**METROPOLITAN GOVERNMENT OF NASHVILLE AND DAVIDSON COUNTY**

**STAFF RECOMMENDATION**  
**1720 5<sup>th</sup> Avenue North**  
**April 15, 2015**

**Application:** New construction—addition; Setback determination  
**District:** Salemtown Neighborhood Conservation Zoning Overlay  
**Council District:** 19  
**Map and Parcel Number:** 081080 47100  
**Applicant:** Brian Perkins and Lauren Williams  
**Project Lead:** Melissa Baldock, melissa.baldock@nashville.gov

**Description of Project:** Application is to construct a rear addition that is both taller and wider than the historic house. The addition requires a setback determination.

Figure 1. 1720 5<sup>th</sup> Avenue North

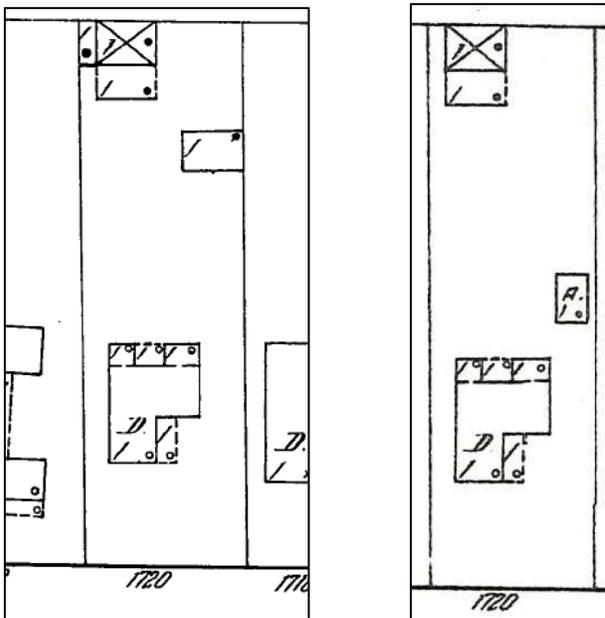
**Background:** 1720 5<sup>th</sup> Avenue North was constructed prior to 1914 and is a contributing structure to the Salemtown Neighborhood Conservation Zoning Overlay (Figure 1). The 1914 and 1957 Sanborn maps show that the form of the existing house has not significantly changed over the last one hundred years (Figures 2 & 3).

Figure 7. The existing curb cut and driveway.

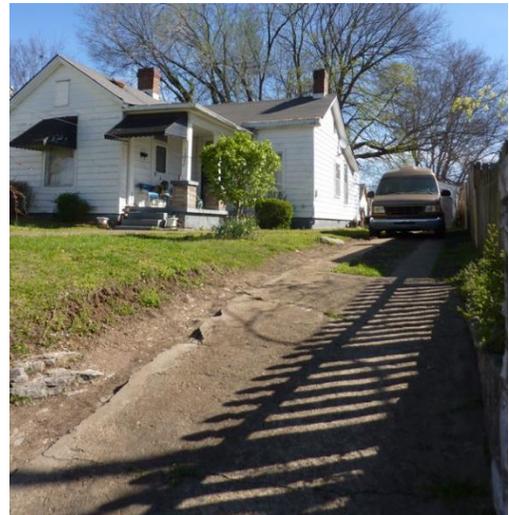
**Orientation:** The new addition will not alter the historic house's orientation towards 4<sup>th</sup> Avenue North. The existing house has two entries on the front façade, which were likely historic and which will be retained. Vehicular access to the site will be from an existing driveway and curb cut (Figure 7). There is also an alley. Staff finds that the project meets Sections III.F. and IV. of the design guidelines.

RIGHT SIDE ELEVATION

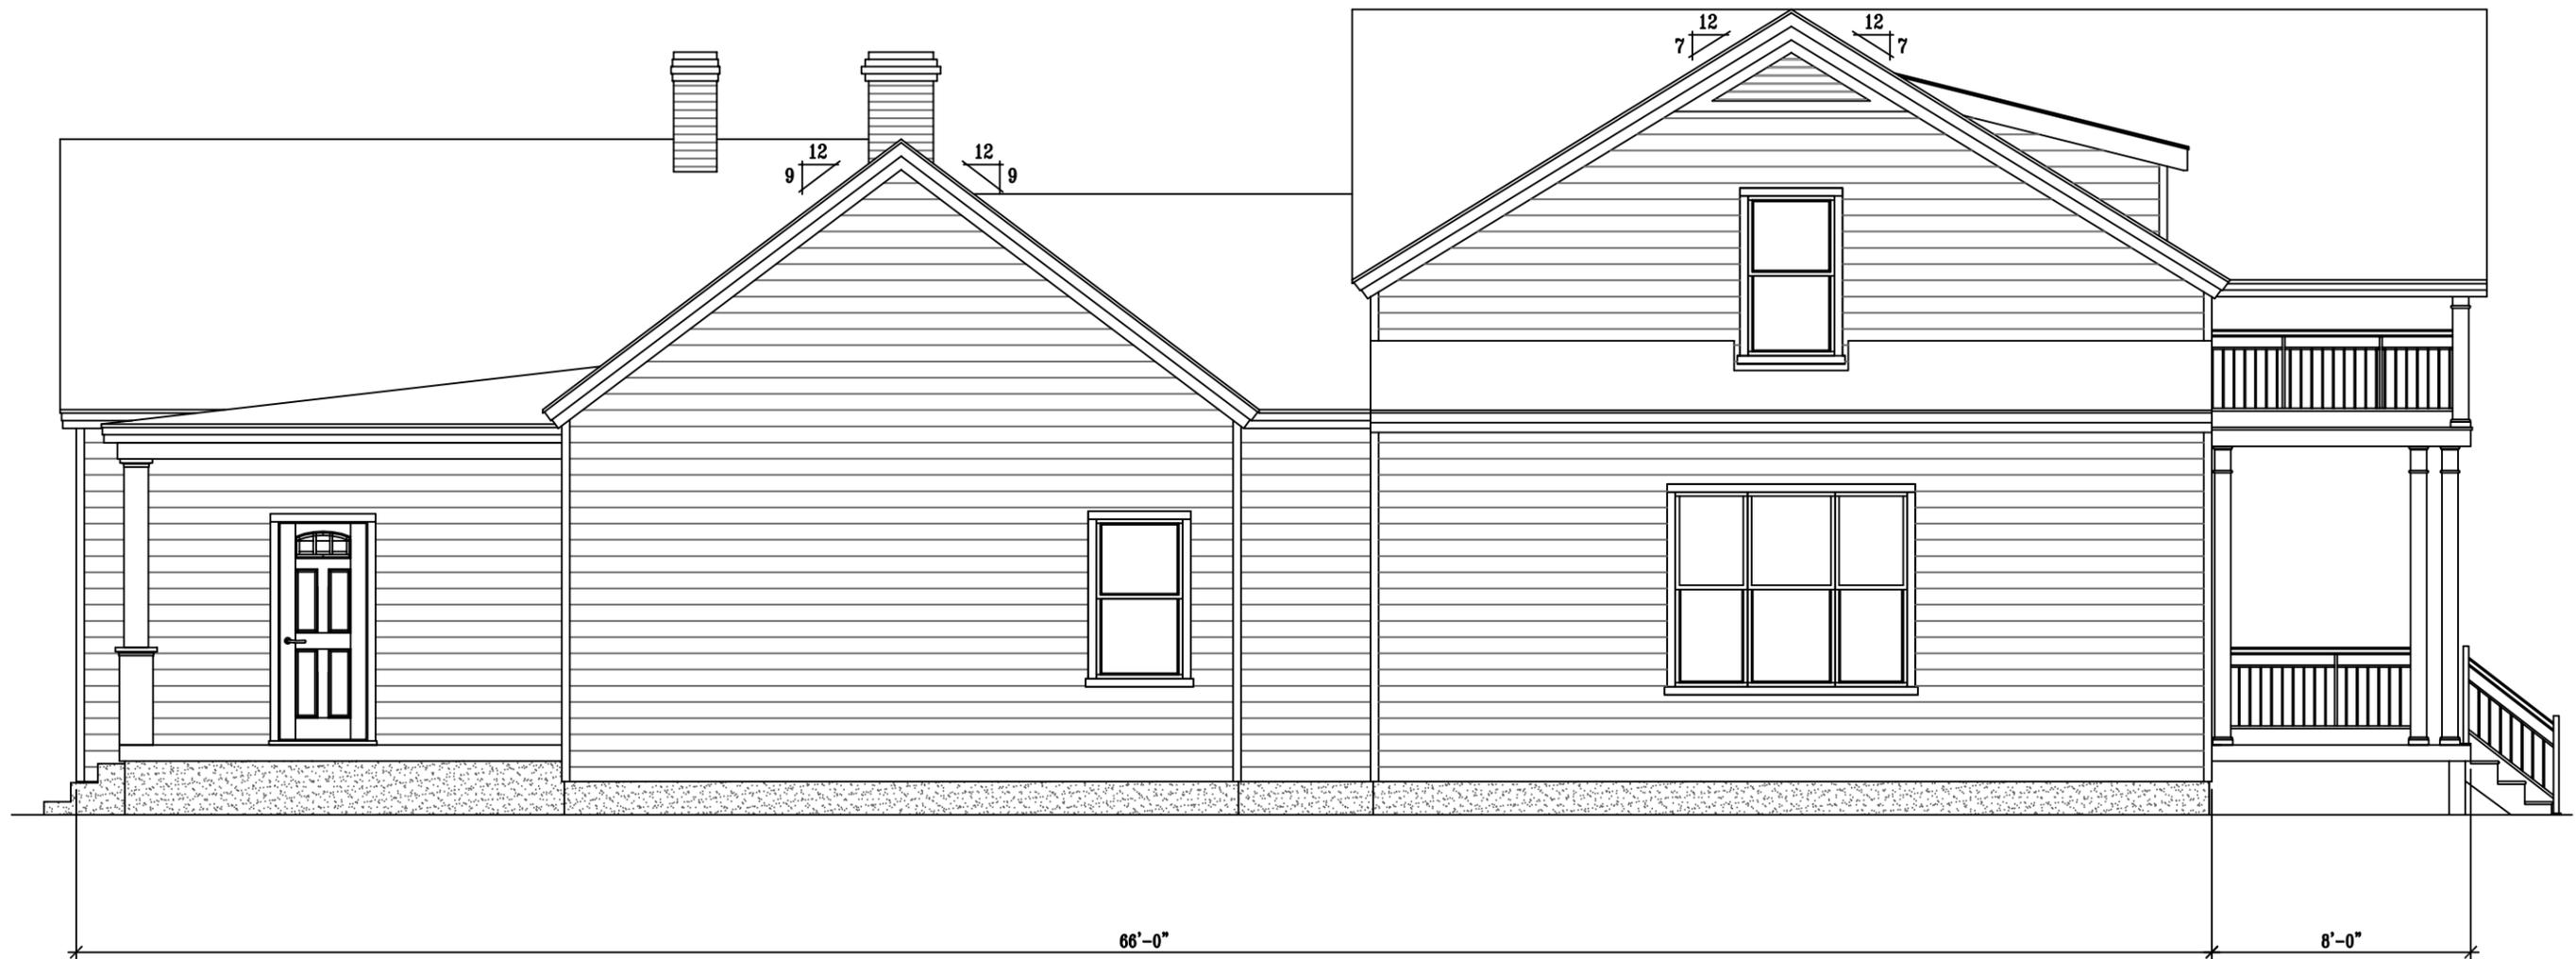
The addition's primary windows are generally twice as tall as they are wide, thereby meeting the historic proportion of window openings. Staff asks that all double and triple window openings, like the one of the right elevation, have four to six inch (4"-6") mullions in between them. The left side elevation of the addition does not have any window or door openings because the wall will be located so close to the side property line. Staff finds this wall expanse without a window or door opening to be acceptable in this instance because the wall will be located over forty feet (40') from the front of the house, and this façade will not be highly visible. Staff finds the project's proportion and rhythm of openings to meet Sections III.G. and IV. of the design guidelines.
